Access Compliance Report

Public Rights-of-Way

(Curb Ramps)

Intersection ID: 15491	Main Street: FARM_POND_LN	Cross Street: WOODBEND_DR	Location: SE
ADA ID: 3DD29E1A819E	Ramp Type: PerpDiag	Initial Pass/Fail: Pass	Overall Compliance: No
			Severity Score: 12.75

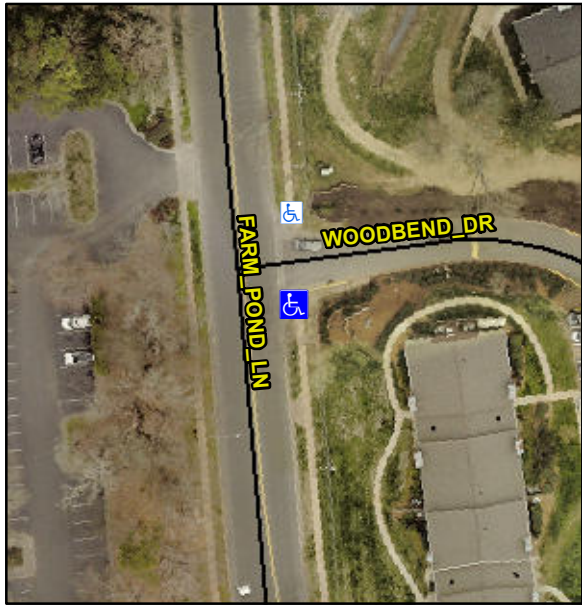
Codes/Mitigation Info/Possible Solution			Field Measurements/Component Compliance					
	Possible Solutions:		Compliance	Description	Data	Compliance	Description	Data
	Remove & Replace Curb Ramp With Two New Directional Ramps or Equivalent.		N/A	Ramp Length (in)	69.0	Yes	Ramp Slope (%)	6.7
			Yes	Ramp Width (in)	48.0	No	Ramp XSlope (%)	2.8
			N/A	Flare Type LT	Sloped	N/A	Flare Type RT	N/A
			N/A	Flare Slope LT (%)	8.6	Yes	Flare Slope RT (%)	5.1
			N/A	Flare Traversable LT?	No	N/A	Flare Traversable RT?	Yes
			No	Landing Length (in)	N/A	Yes	DWS Provided?	Yes
			No	Landing Width (in)	N/A	Yes	DWS Contrast?	Yes
			No	Landing Slope (%)	N/A	Yes	DWS Length (in)	24.0
			No	Landing X Slope (%)	N/A	No	DWS Full Width?	No
	Surveyor Notes:		N/A	Landing Curb? (Y/N)	No	Yes	DWS Offset (in)	2.0
	PROW/ADA:		N/A	Shared Landing?	N/A			
	Not Found, R304.5.3, R304.2.1, R304.2.2-Perp, R304.3.2-Para, R305.1.4		Yes	Gutter Ponding?	No	Yes	Gutter Slope (%)	4.8

Yes	Gutter Lip Ht (in)	0.0	Yes	Gutter X Slope (%)	0.9
			N/A	Painted X Walk1?	No	N/A	Painted X Walk2?	No
				X Walk 1 Direction	To N		X Walk 2 Direction	To W
			N/A	X Walk 1 Width (in)	N/A	N/A	X Walk 2 Width (in)	N/A
				X Walk 1 Slope (%)	0.1		X Walk 2 Slope (%)	1.2
				X Walk 1 X Slope (%)	1.3		X Walk 2 X Slope (%)	0.5
			N/A	Ramp inside XWalk1?	N/A	N/A	Ramp inside XWalk2?	N/A
			Road Slope (%)	0.9	N/A	Clear Space?	Yes	
			Road X Slope (%)	1.6	N/A	Clear Space to XWalk (in)	N/A	
		Yes	Any Obstructions?	No	Yes	Storm Grate/Utility Hazard?	No	
			Obstruction Type			Storm Grate/Utility Type		
					N/A			N/A
					Yes	Surface Condition? (G/P)	Good
